Work Order ID: 72567

Parent Item Name: Step Modification

# **DART SERVICE INSTRUCTION**

TO AMEND DRAWING D350-591 REV. F

**FIGURE 1 - CLAMP/CUSHION INSTALLATION**

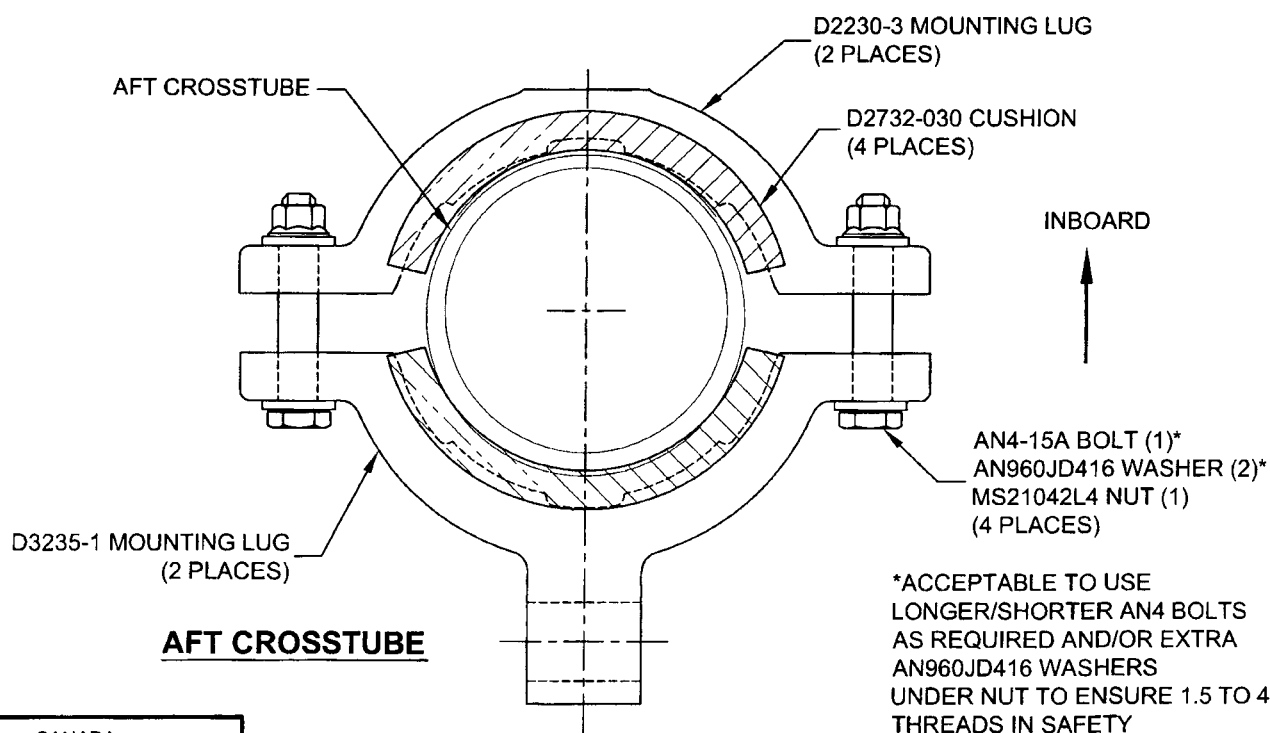
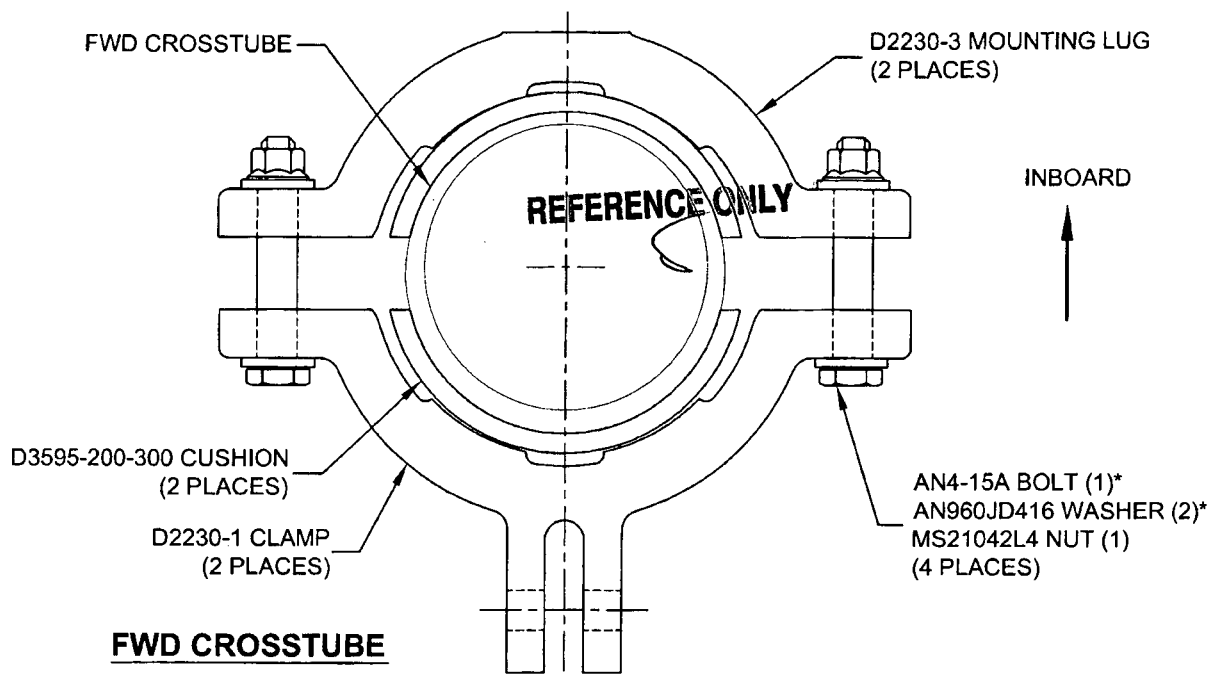
TO IMPROVE THE FIT OF THE D350-591-311/-312 STEPS, IT IS ACCEPTABLE TO INSTALL THE DSI 9410-011 KIT. INSTALL THE D2732-030 CUSHION (AFT CROSSTUBE ) AND D3595-200-300 CUSHION (FWD CROSSTUBE) AS SHOWN IN FIGURE 1 IN PLACE OF THE D2856-400-720 ABRASION STRIP CALLED OUT ON DRAWING D350-591 REV. F.

FOR CUSTOMERS WHO HAVE PREVIOUSLY INSTALLED D2856-400-720 ABRASION STRIPS REMOVE THE ABRASION STRIPS IN ACCORDANCE WITH ICA-D350-591. PRIOR TO INSTALLING THE DSI 9410-011 KIT.

\*ACCEPTABLE TO USE  
LONGER/SHORTER AN4 BOLTS  
AS REQUIRED AND/OR EXTRA  
AN960JD416 WASHERS  
UNDER NUT TO ENSURE 1.5 TO 4  
THREADS IN SAFETY
